STATE OF VERMONT AGENCY OF TRANSPORTATION

PROPOSED IMPROVEMENT TOWN OF PERU COUNTY OF BENNINGTON VT ROUTE 11 (MINOR ARTERIAL)

Record Plans

DIRECTOR OF PROJECT DELIVERY	APPROVED DATE 12/31/2014
PROJECT MANAGER : KEN UPMAL, P.E.	
PROJECT NAME : PERU	
PROJECT NUMBER : STP SCR(4)	
SHEET 1 OF 45 SHEETS

# PROPOSED CULVERT

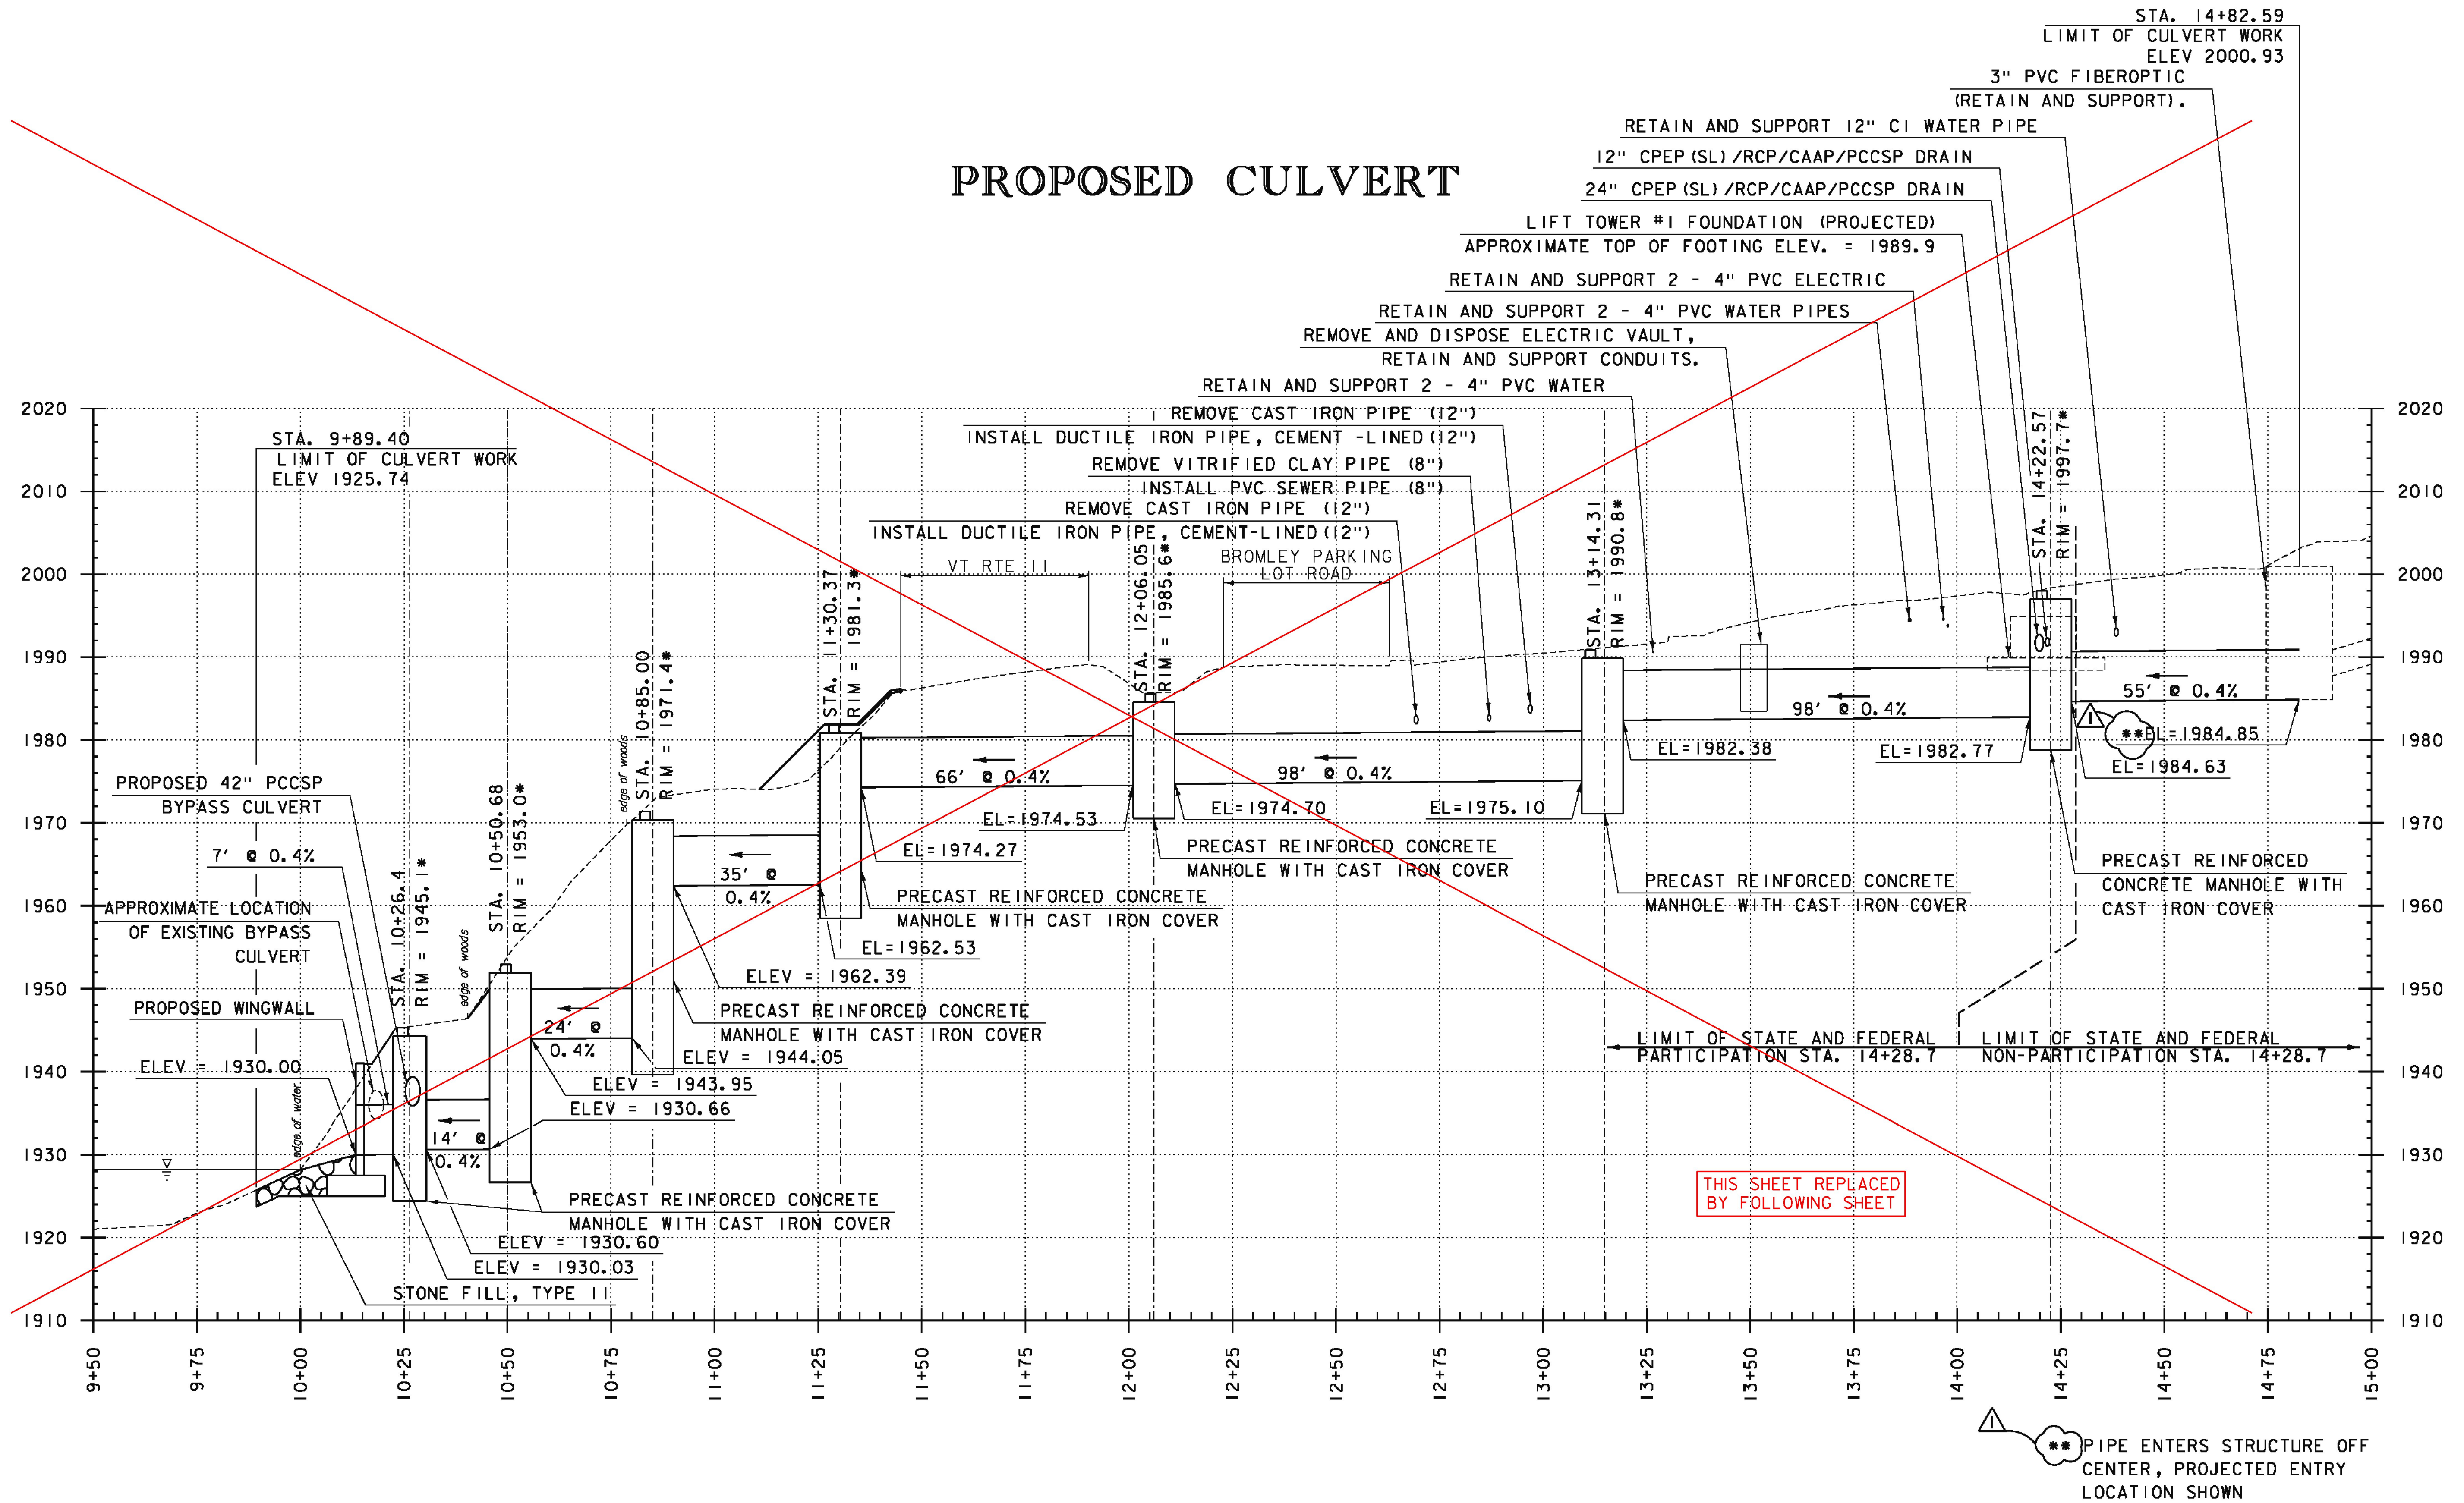
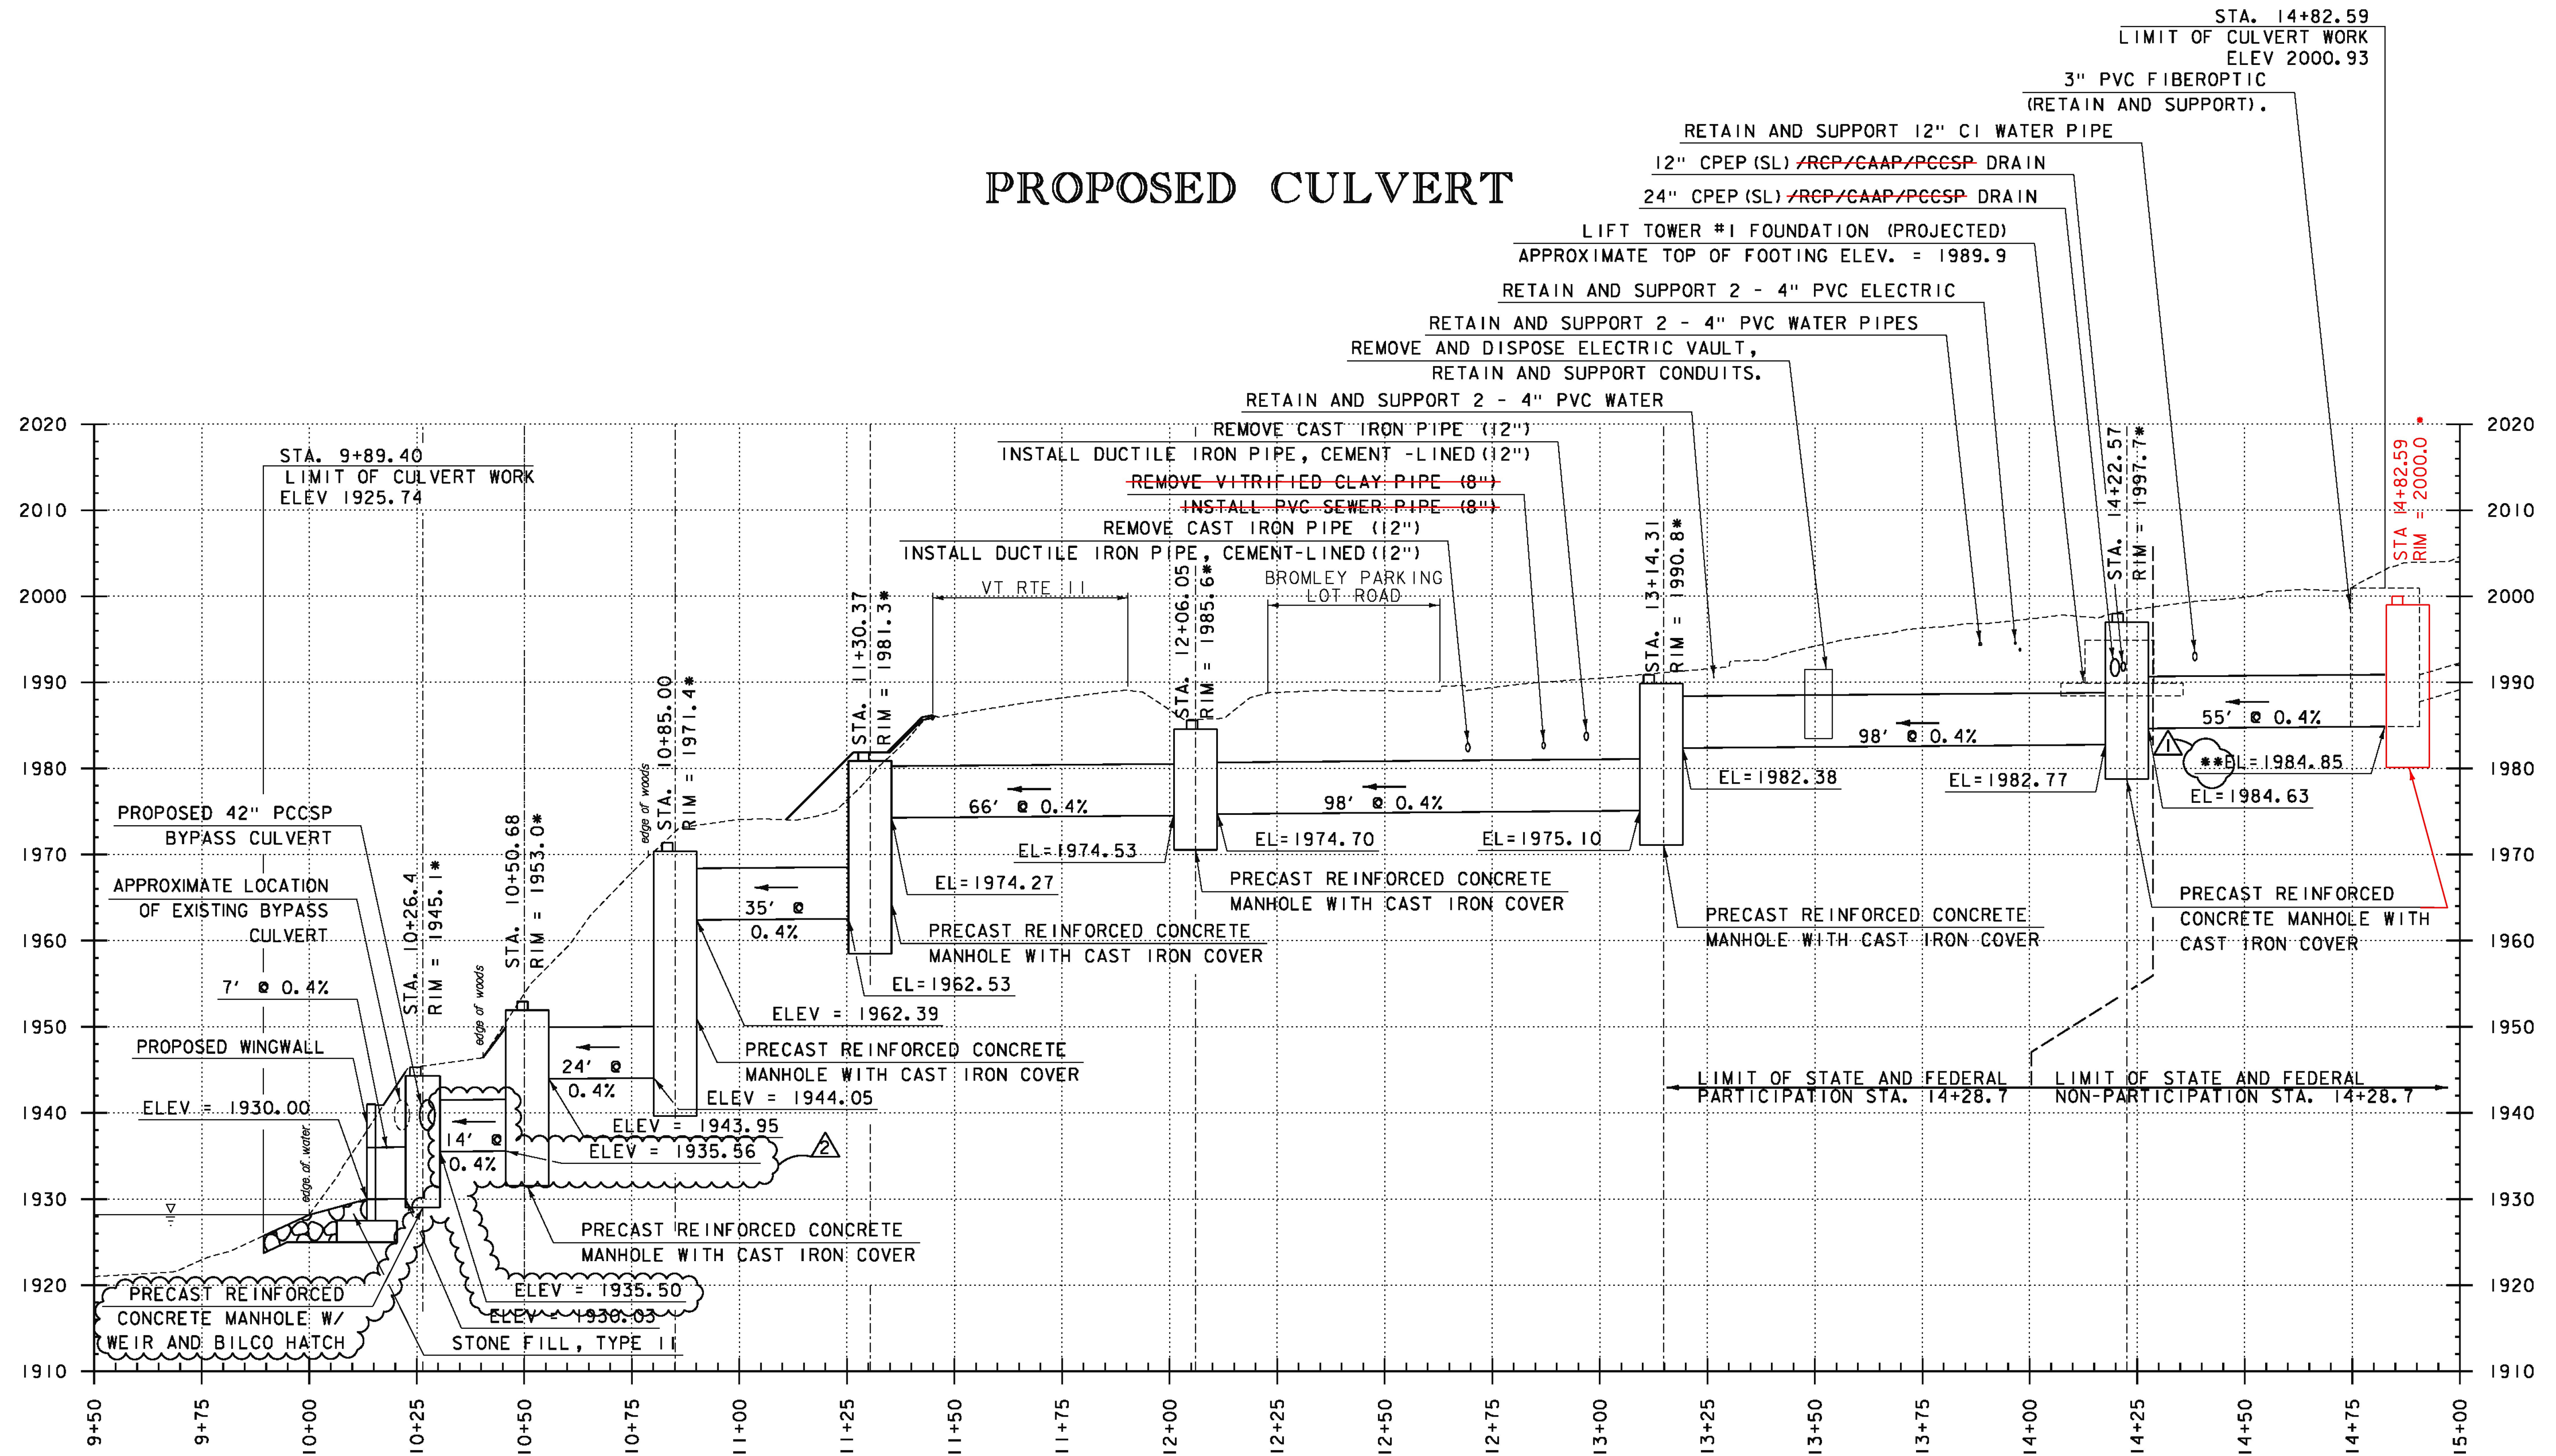
REVISION	BY	DATE
△ SECOND ASTERISK WAS ADDED TO NOTE AND ELEVATION CALLOUT	MAB	2/10/2015
△ PROFILE UPDATED TO REFLECT ADDITION OF BAFFLE W/ WEIR.	MAB	6/8/2015

△ ** PIPE ENTERS STRUCTURE OFF CENTER, PROJECTED ENTRY LOCATION SHOWN
